Issued for comments/ Approval

CLIENT:  
**HUWS GRAY**

PROJECT:  
**WILLOW BANK**

DRAWING TITLE:  
**FF DWELLING**

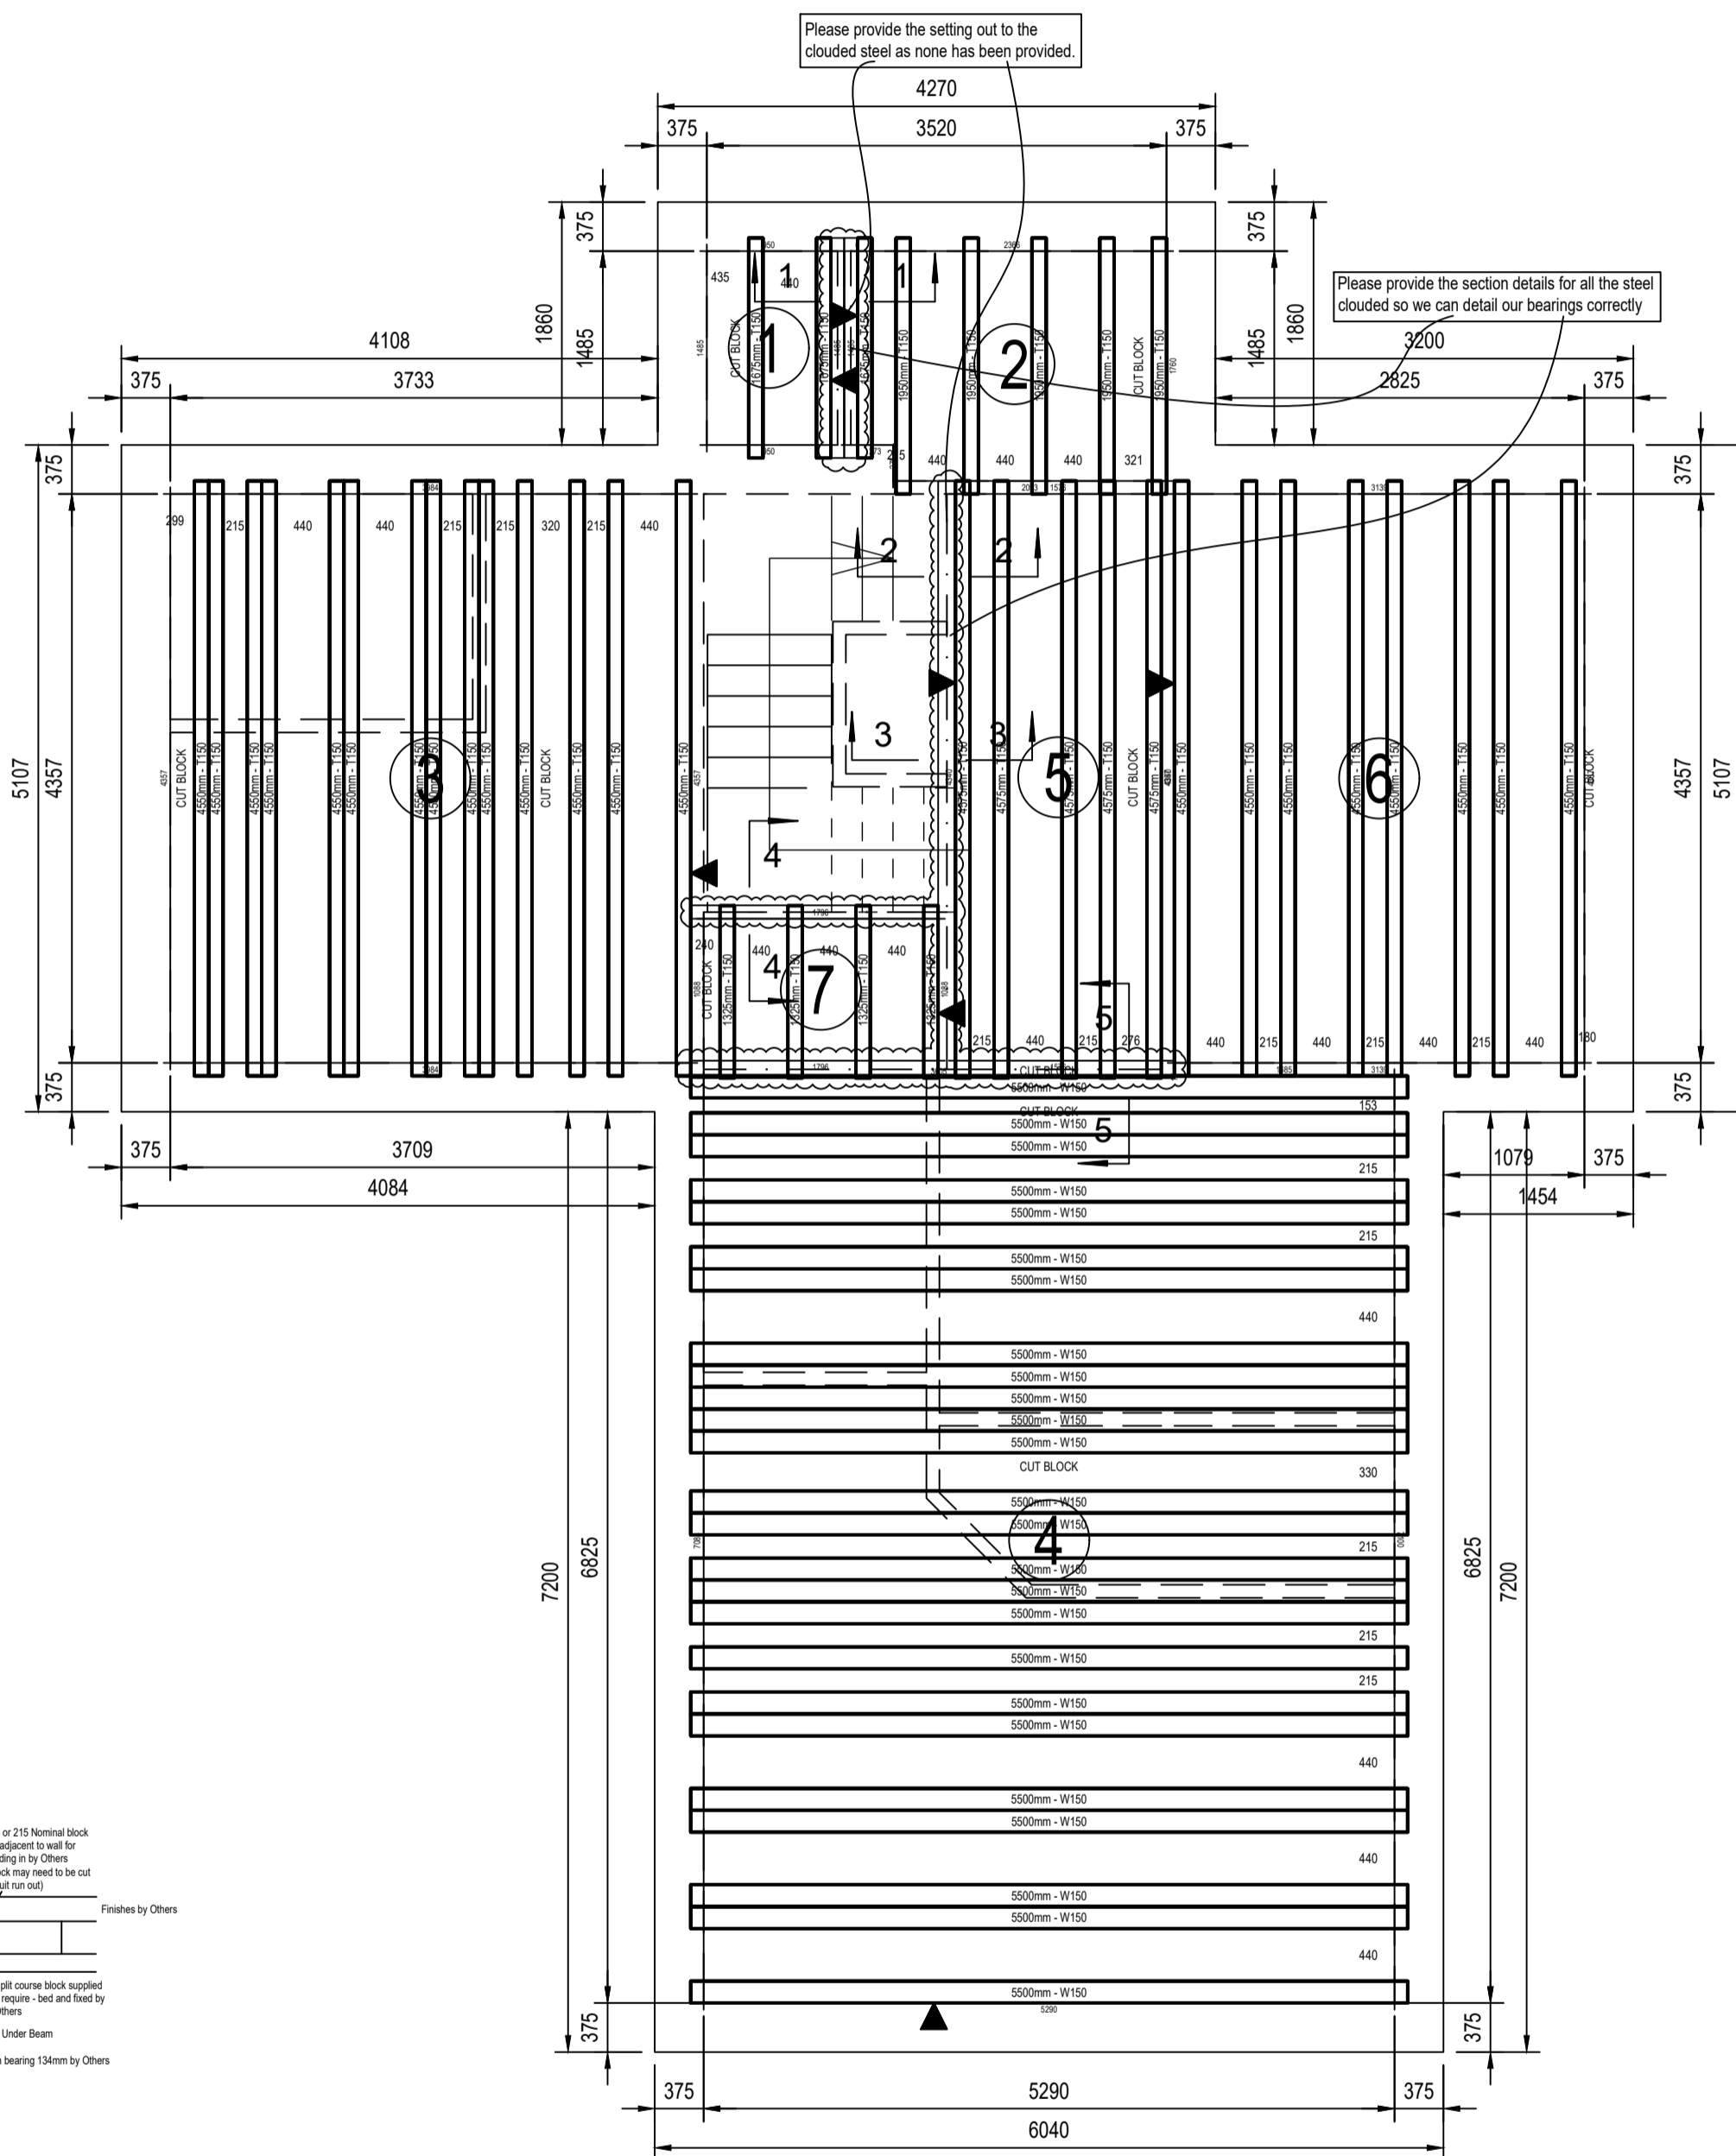
Please advise it has been assumed that all partitions are block work walls please confirm if this is correct or not.

Please advise it has been assumed that the area where the stairs are to rise up to the first floor is to be void.

Please provide the setting out to any service hole which are to rise up through the beam and block.

Please provide the load to all the unfounded block work partitions so they can be supported.
